Preliminary Field Check For Drip Systems

Permit of Authorization to Construct an On-Site Sewage Facility Permit Valid For One Year From Date Issued

Permit Number: 116147
Issued This Date: 04/29/2024
This permit is hereby given to: Y&JB HOMES MASTER, LLC

1058 CHISOLM TRL
SPRING BRANCH, TX 78070

**TYPICAL PUMP TANK CONFIGURATION
NU-WATER 550PC -400PT 768 GAL PUMP TANK**

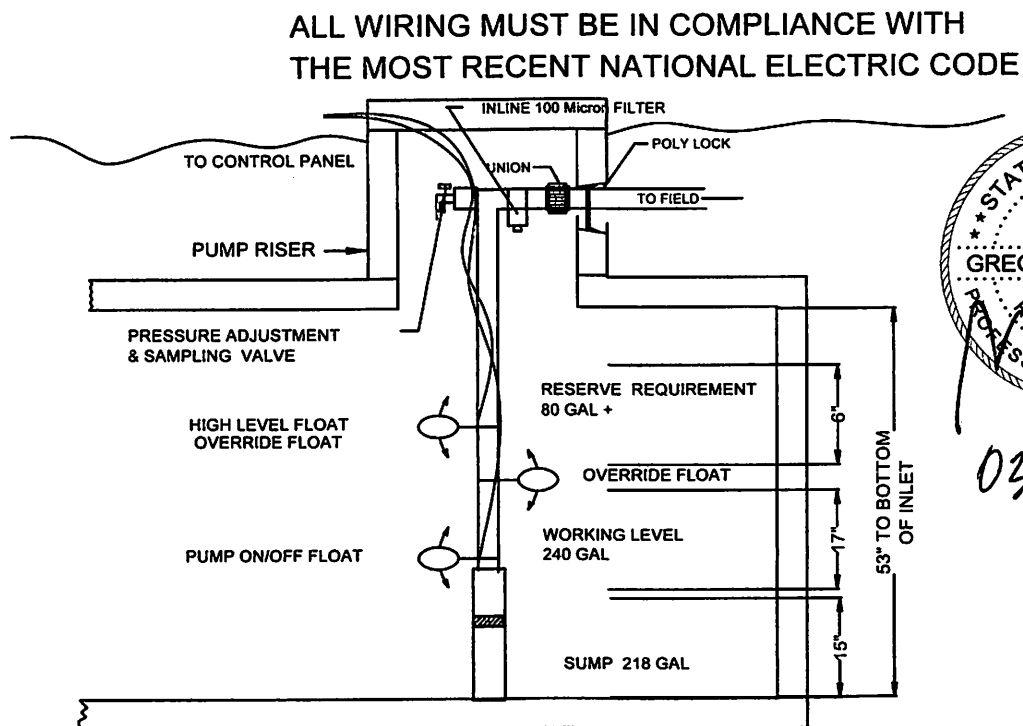
- 1.  A minimum of 12 inches of soil is required between the drip tubing and the top of the ATU/tanks.**
- 2. Revise as needed and resubmit.**
